Town of Franklin

Planning Board

June 8, 2020

- 7:00 PM Commencement/General Business
- 7:05 PM <u>PUBLIC HEARING</u> Continued 176-210 Grove Street Site Plan

FILED AT THE OFFICE OF THE TOWN CLERK DATE: APPROVED BY VOTE OF TOWN MEETING DATE: ------TOWN CLERK APPROVAL UNDER THE SUBDIVISION CONTROL LAW NOT REQUIRED. FRANKLIN PLANNING BOARD FRANKLIN SELECTBOARD DATE: A A A 2 1 ∆=90°00'00' R=30.00' T=30.00' L=47.12' 0 12 513 DATE 12/5/13 DATE 27,137

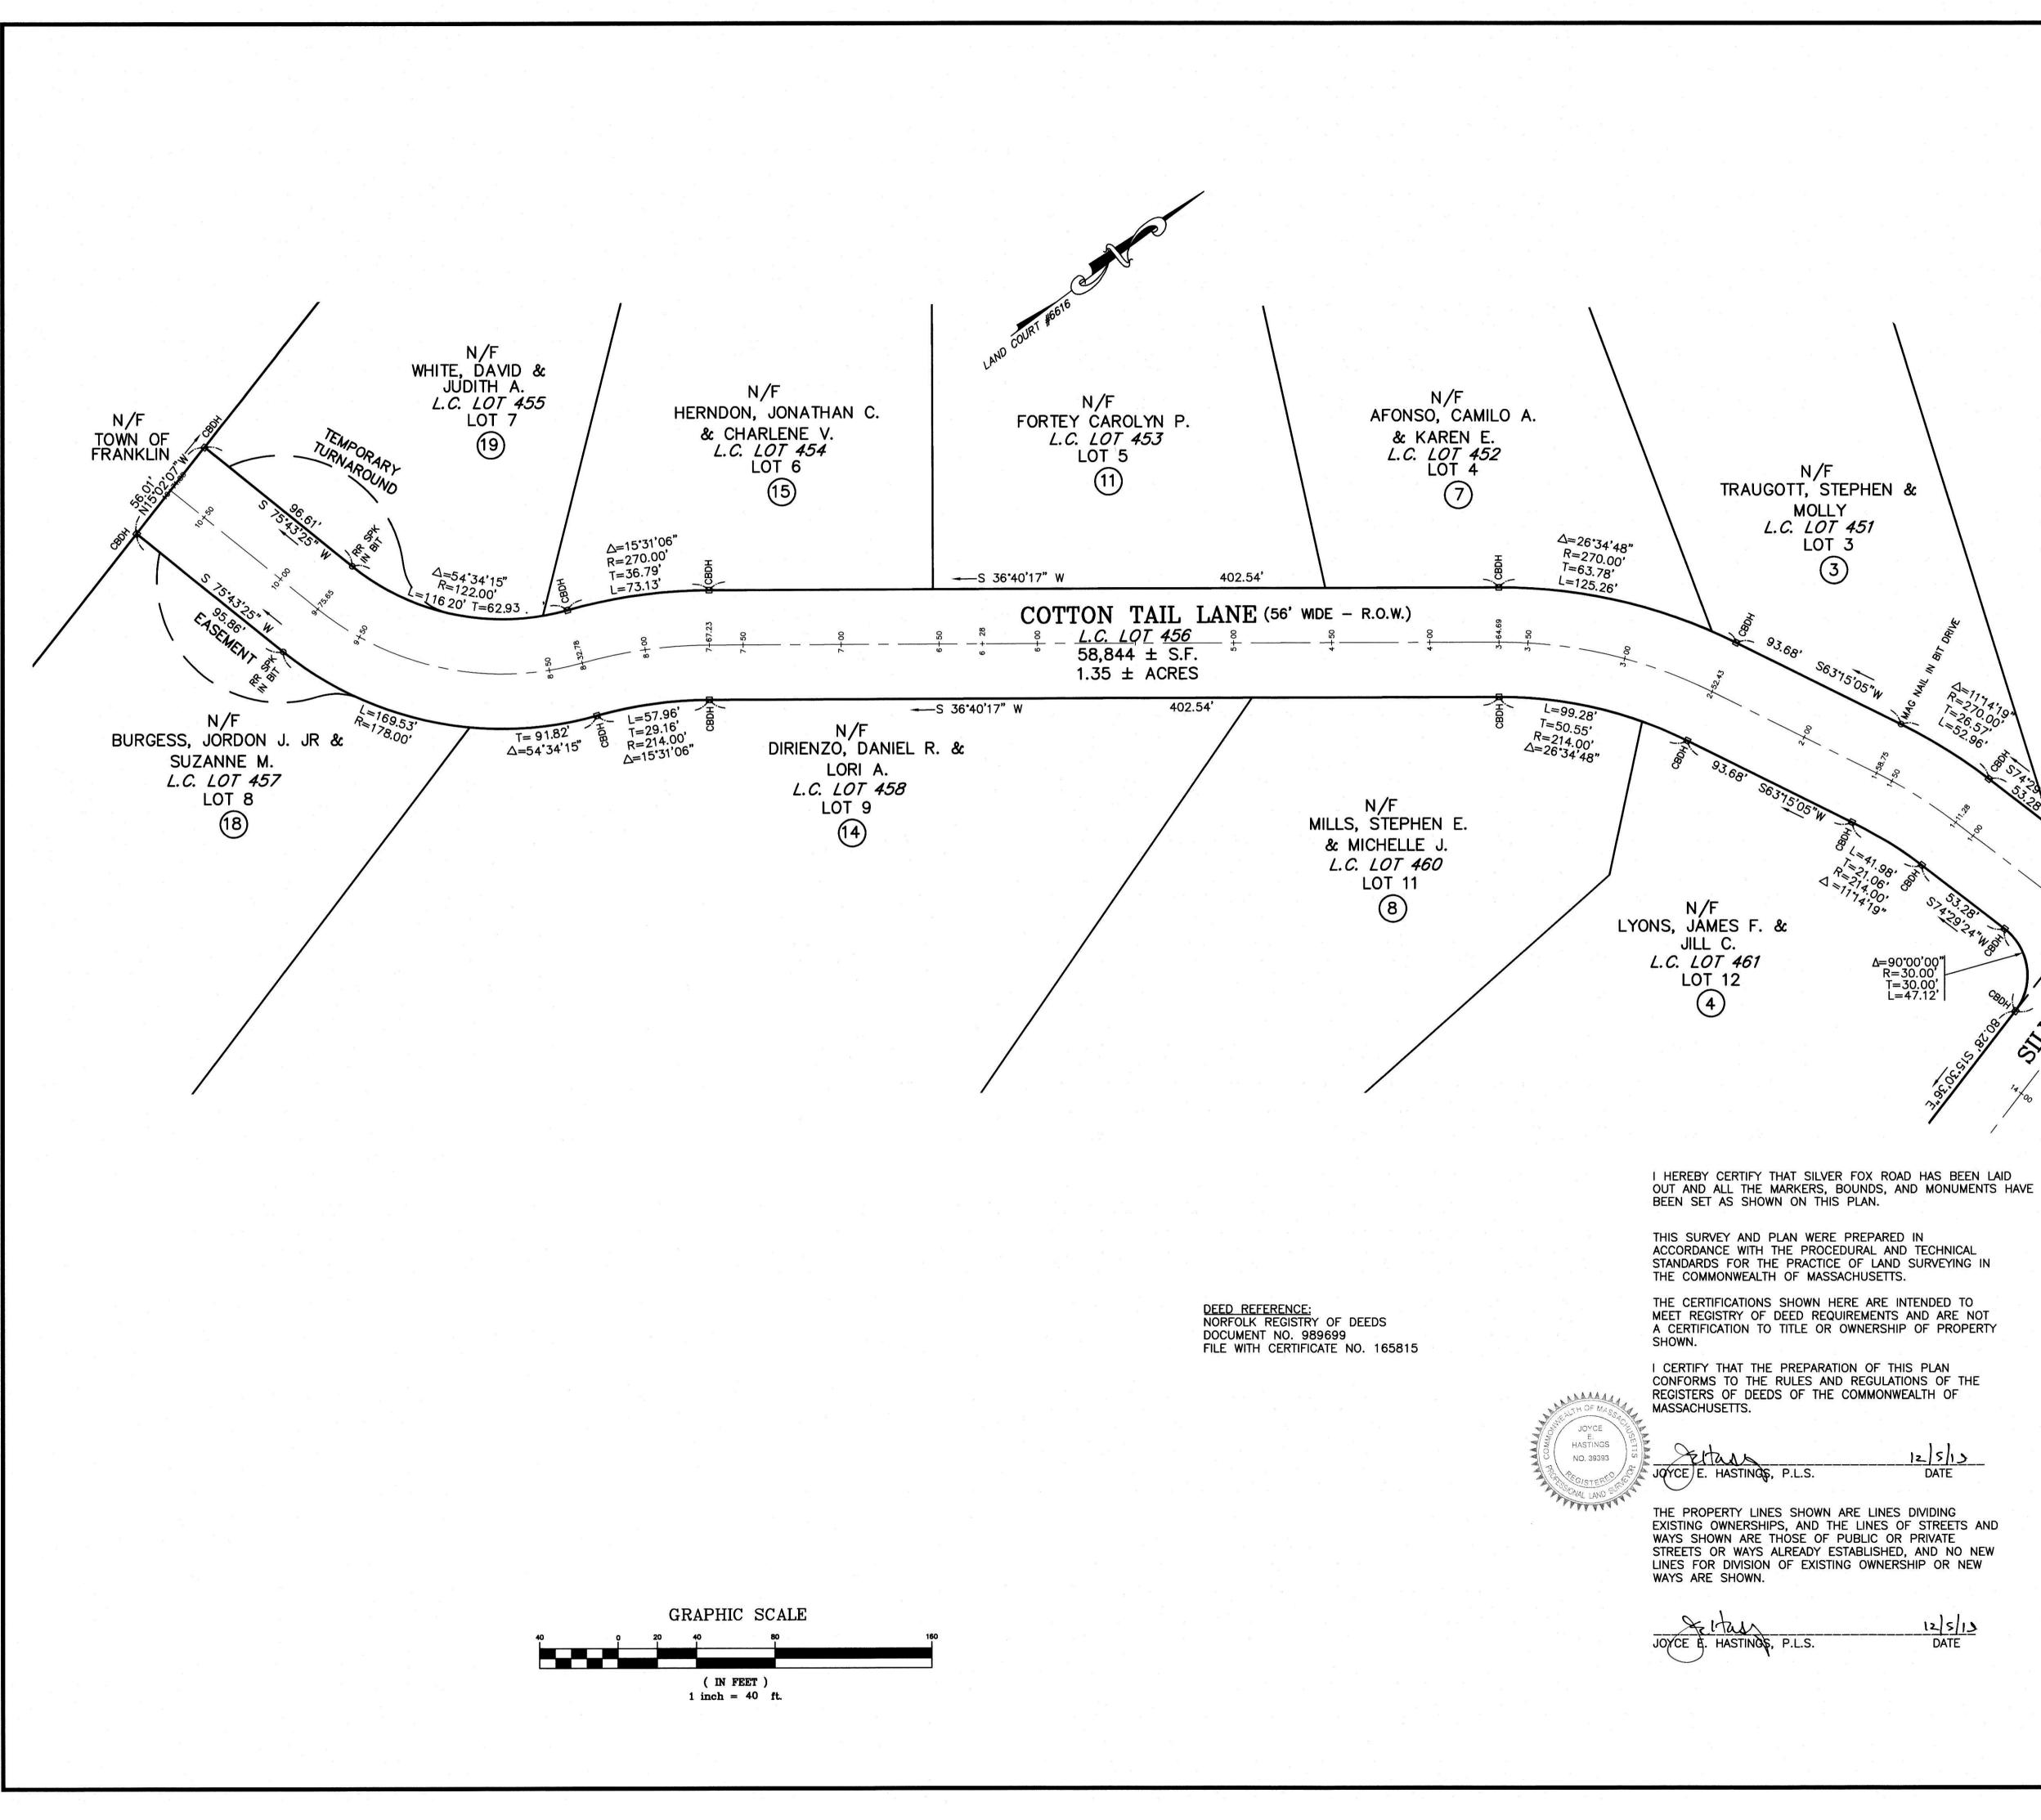
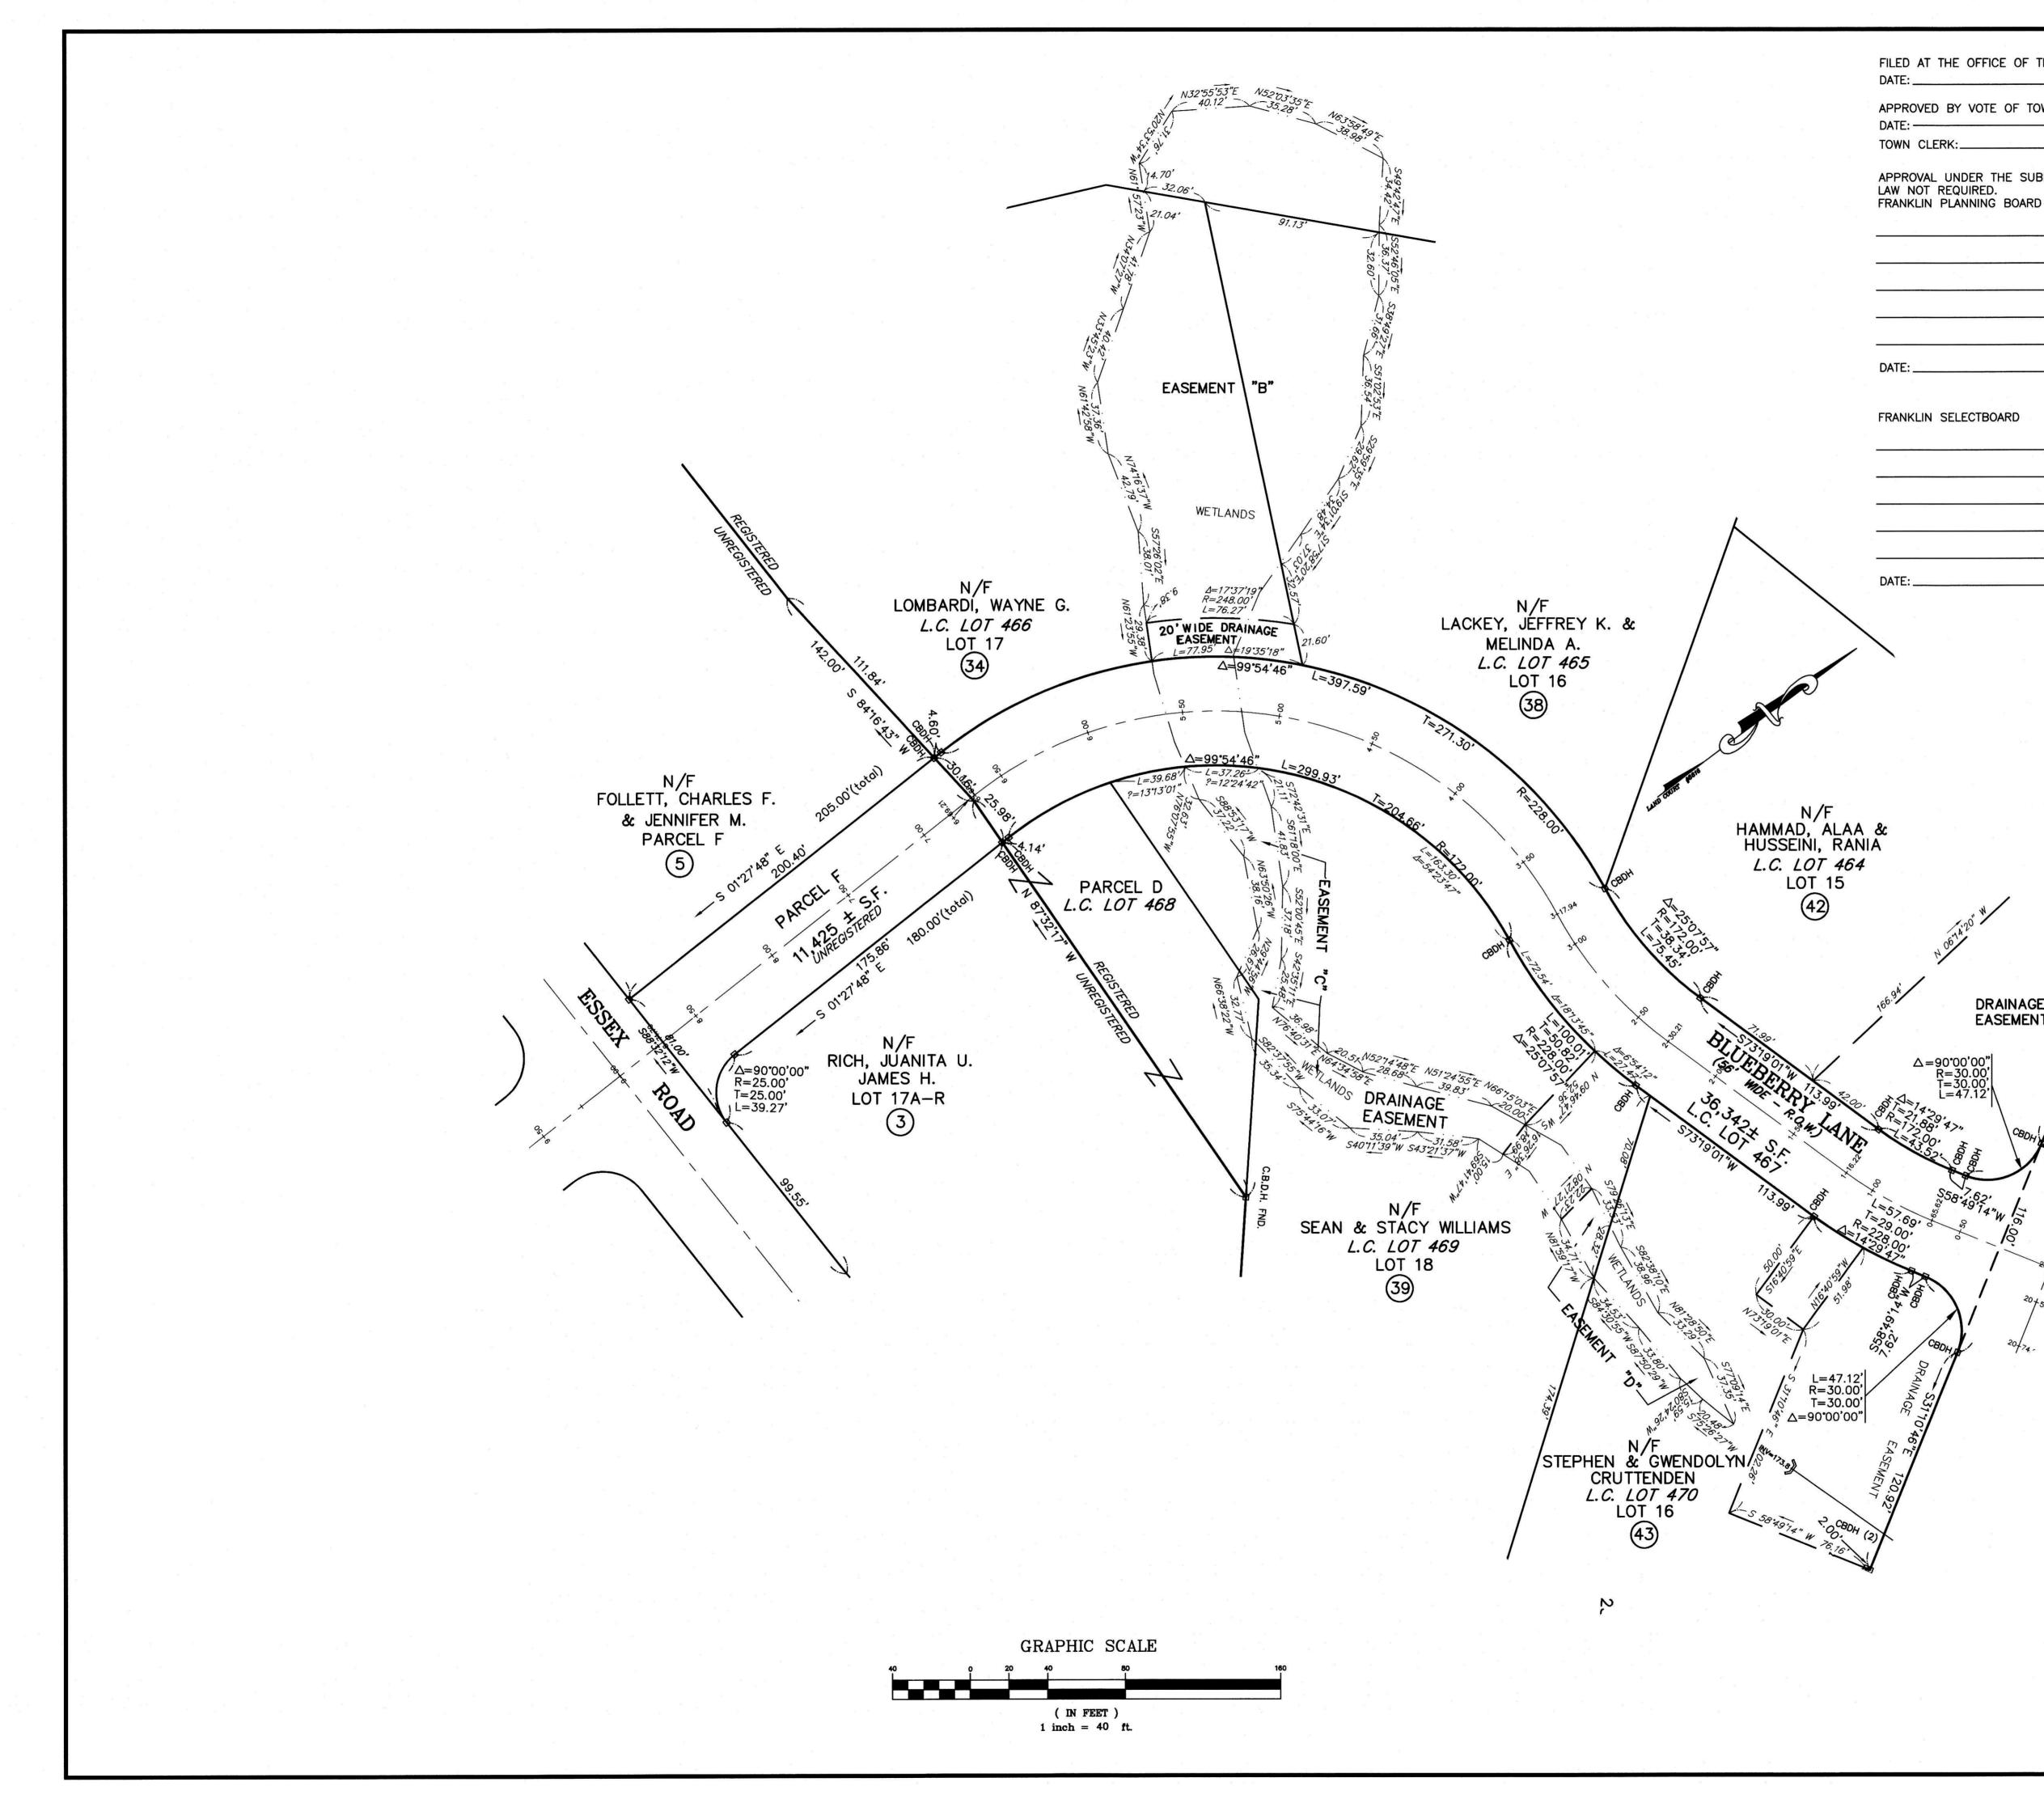
- 1. The Applicant has submitted Road Acceptance for the following streets:
 - a. Silver Fox 0+00-0+12 Bond Amount \$136,673
 - b. Cotton Tail 5+00-10+50 Bond Amount \$24,050
 - c. Blueberry Land 13+00-20+50 Bond Amount \$22,860
 - d. Cotton Tail 0+00-5+00 Bond Amount \$10,000
- 2. All necessary documentation has been submitted to the Town Attorney and Town Engineer for review.

- DPCD recommends releasing 3 out of 4 bonds.
 - Bonds to be release are \$136,673, \$24,050, \$22,860 = \$183,583
- DPCD recommends holding \$10,000 until streets are accepted by Town Counsel and recorded at the Registry of deeds.
- Planning Board will also need to vote to recommend street acceptance to the Town Counsel
